Docket 52-002

Subject: *ABB Combustion Engineering Topical Report CENPD-210, Revision 7A*

QUALITY ASSURANCE/QUALITY CONTROL FUNCTIONS

FIGURE 1

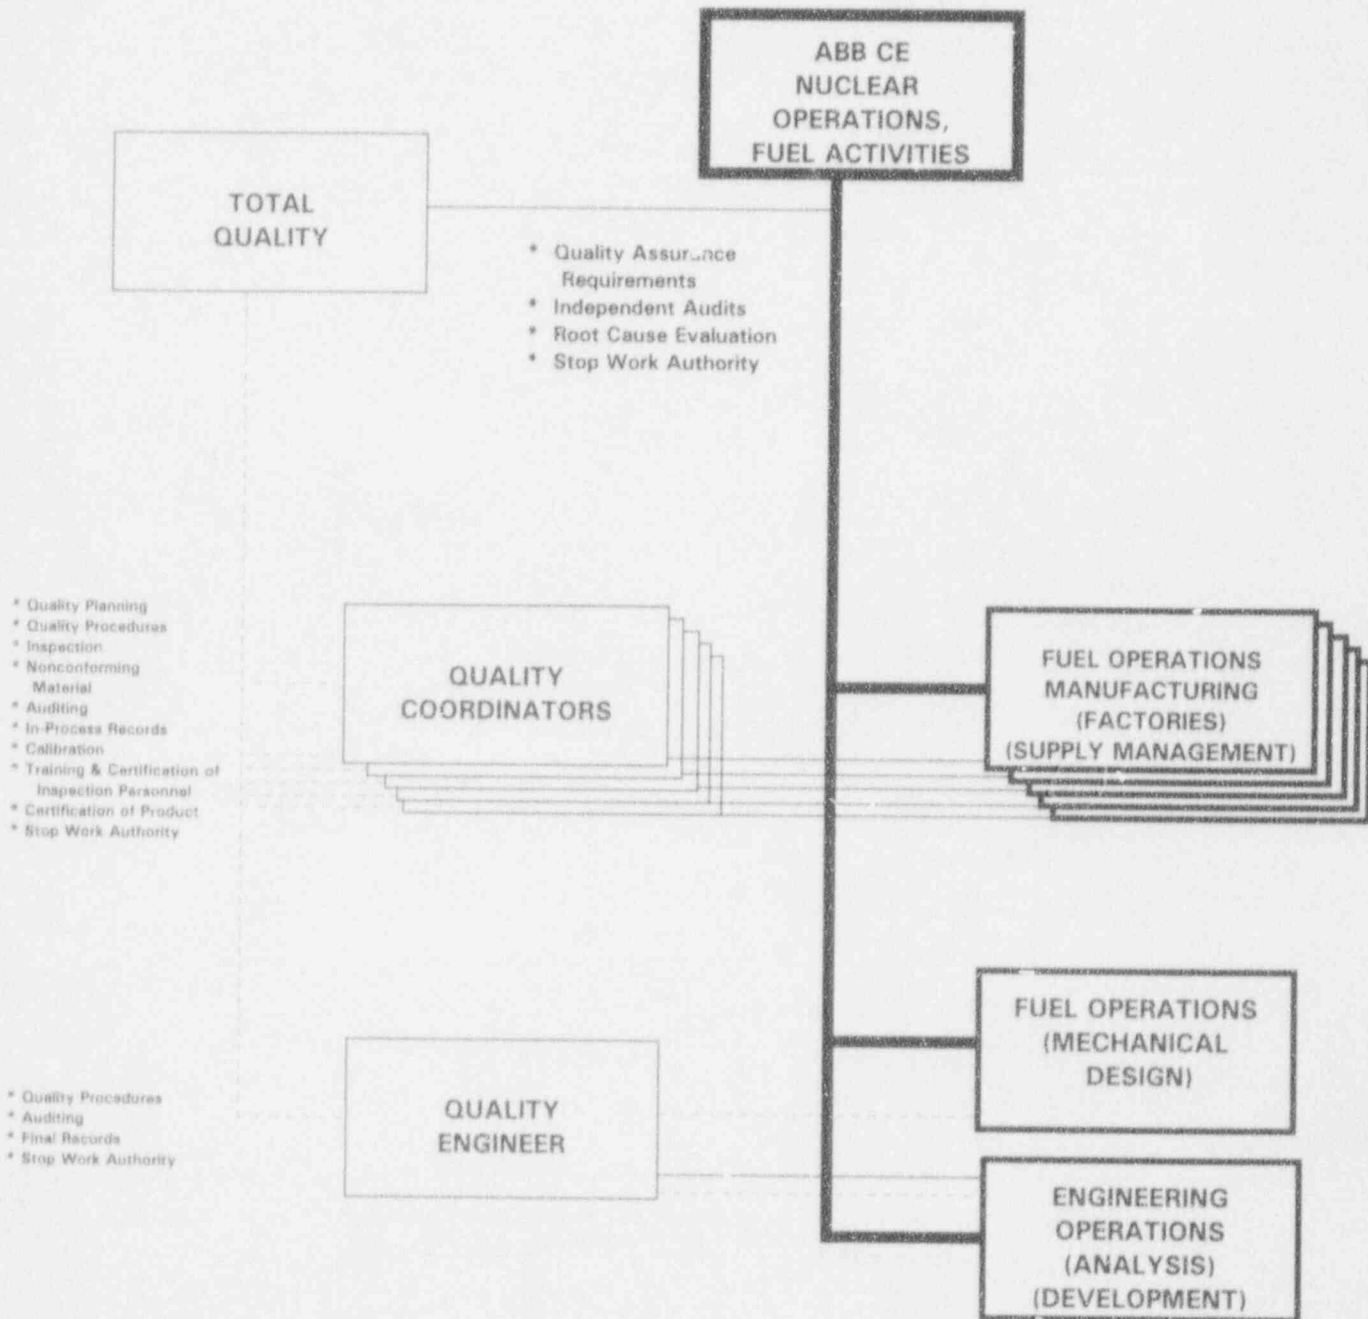
Figure 1, attached, outlines the new organization and supersedes Figure II-2 of CENPD-210, Revision 7A, and letter LD-92-108.
